## ***Interactive comment on* “Exploration of land-use scenarios for flood hazard modeling – the case of Santiago de Chile” by A. Müller and F. Reinstorf**

**A. Müller and F. Reinstorf**

Received and published: 14 July 2011

**Fig. 1.** Result of the hydrologic modeling using HEC-HMS: Precipitation data from Cerro Calán station and modeled hydrograph at San Ramón station for rainfall event in May 2002

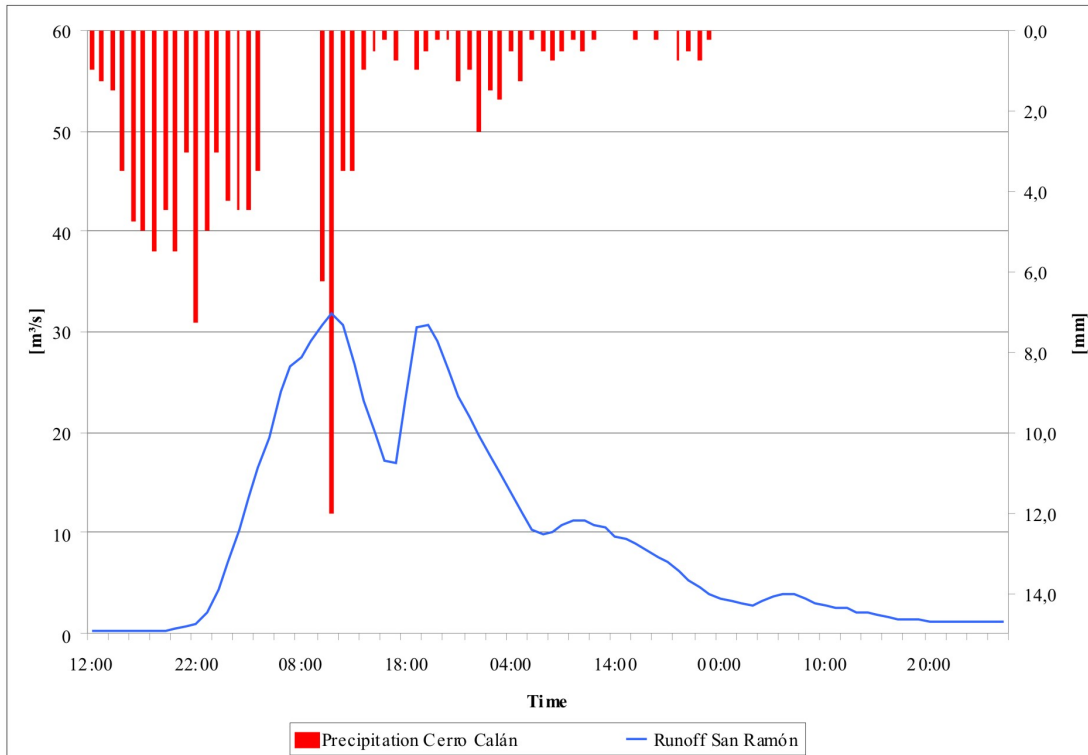
Question: In general, the paper is a good description of the modeling effort, but the presentation of the results is somewhat lacking in terms of detail and interpretation. For the most part, the paper does not provide new and interesting insights into the hydrology of the study area. Response: It will be added to the text on page 4005, after line 25: The following two Figures 4 and 5 give some more insight in the catchment hydrology during two rainfall events with a return period of 25 years at two different points in time. The total precipitation was 113.5 mm for the event in May 2002 and 148 mm in August 2005. The peak runoff was 31.9 m<sup>3</sup>/s and 45.6 m<sup>3</sup>/s respectively. The total runoff volume was 87.13 m<sup>3</sup>/s in May 2002 and 121.02 m<sup>3</sup>/s in August 2005.

The hydrographs exemplify how the runoff recedes as soon as the precipitation stops or significantly minimizes. That stands for a fast drainage of the rainwater and a direct response of the runoff on precipitation. The temporal delay, i.e. the response time of the watershed is thereby approximately eight to ten hours. The difference between the two events in May 2002 and August 2005 is the duration of the rainfall as well as a changing LULC pattern in the basin that could be observed during the three years that lay between both modelling time steps. The tendency of the proportional increase in the total amount of runoff at the gaging station becomes obvious in the two examples. The influence of land-use changes on the peak runoff is exemplified in the results of Table 7.

Fig. 3. Hydrograph for the different LULC patterns for the rainfall event in July 2001

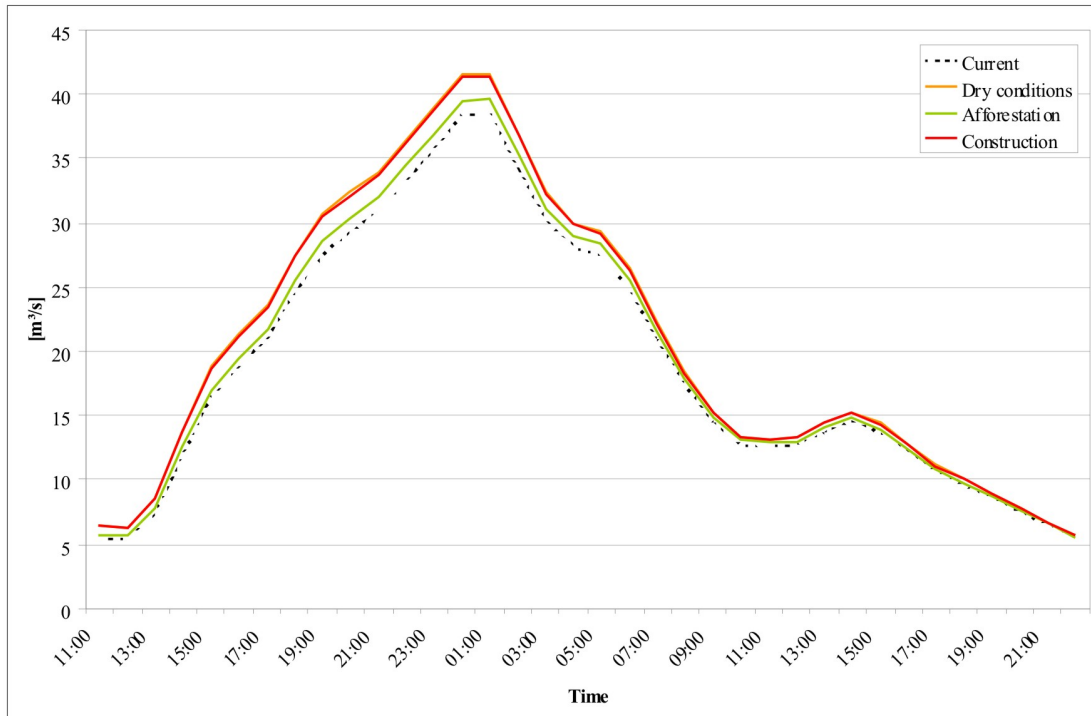
No results of the modeling are shown in the figures. Why not? It could be added to the text on page 4006, line 8: The following figures 6 and 7 show the modelling results from the three land-use scenarios and the conditions of the respective year (current, dashed

line) from the rainfall events in July 2001 and in September 2009. It becomes apparent that the runoff in 2002 was still lower than in the afforestation scenario for 2030. In 2009 the loss of vegetation in comparison to 2002 already shows an increase in runoff. Thus, the best scenario option in this case would be afforestation. Both dry conditions and construction activities show the highest peak flows whereby the construction scenario with irrigated private green spaces shows slightly lower runoff values than Scenario I with the dry conditions.
